Subject: **Drainage Control Modifications for Pit 10, NOV 21167, and Task Id. 5180, Alton Coal Development, LLC, Coal Hollow Mine, C/025/0005**

Permittee: Alton Coal Development, LLC
Mine: Coal Hollow Mine
Permit Number: C/025/0005
Title: Drainage Control Modifications for Pit 10

Permittee: Alton Coal Development, LLC
Mine: Coal Hollow Mine — Permit Number: C/025/0005
Title: Drainage Control Modifications for Pit 10

DRAWING: 5-3C

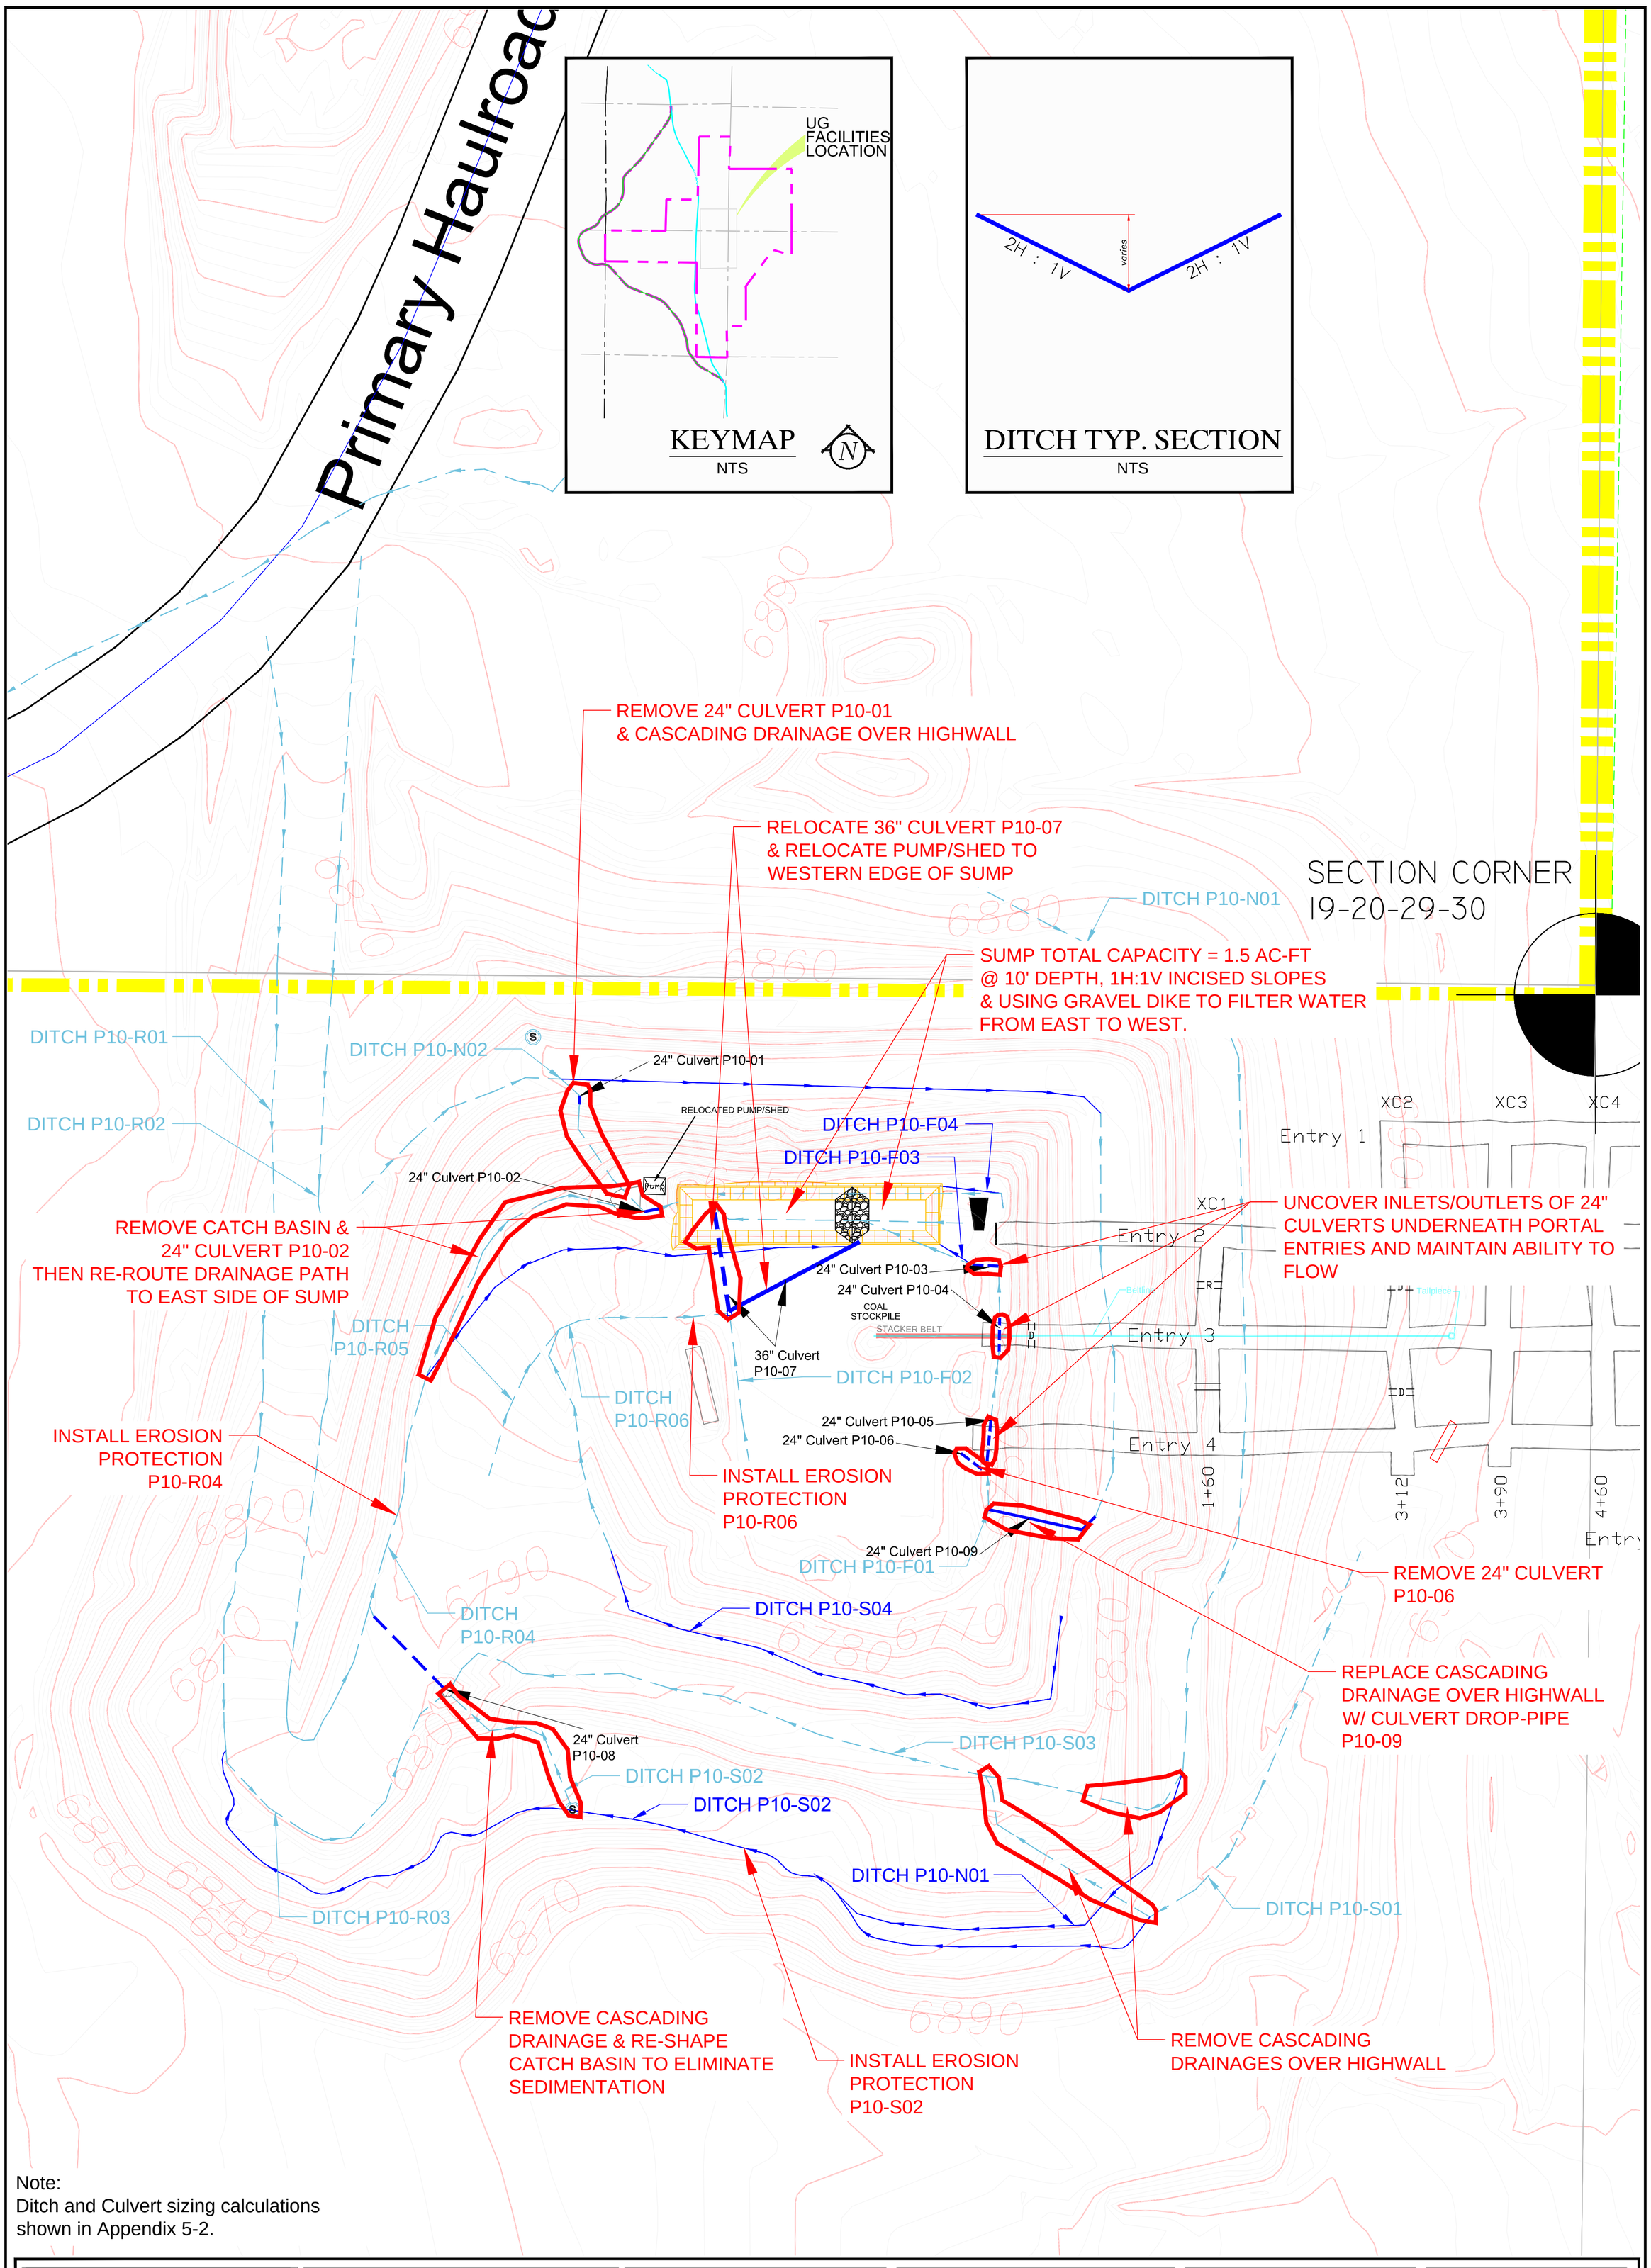
- **Portal Drainage and Sump Design**
  The existing sump in the portal area pit has been redesigned and expanded to reduce the possible sediment load being pumped to Pond 3 as described above. The area draining to the sump has been measured at 25.2 acres. Using the 100 year – 24 hour storm event of 3.1", the calculated total runoff from this area is 1.42 acre feet. In an effort to reduce sediment loading to the sump and Pond 3, the sump will be expanded and divided into 2 sections by installation of a gravel filter dike. The contaminated runoff from the ditches and portal area will flow to the eastern section. Sediment will be allowed to settle in this section as the water filters through the gravel to the western or "clean water" section. The western section will have a capacity of at least 1.00 acre foot. Mine water will continue to flow to the western section, and pumping to Pond 3 will continue as designed and approved. The expanded sump will be constructed with approximately 1H:1V internal slopes and incised as originally constructed.

Note: Drainage control details for the portal area are shown on Drawing 5-3C. Watersheds are shown on Drawing 5-3D.
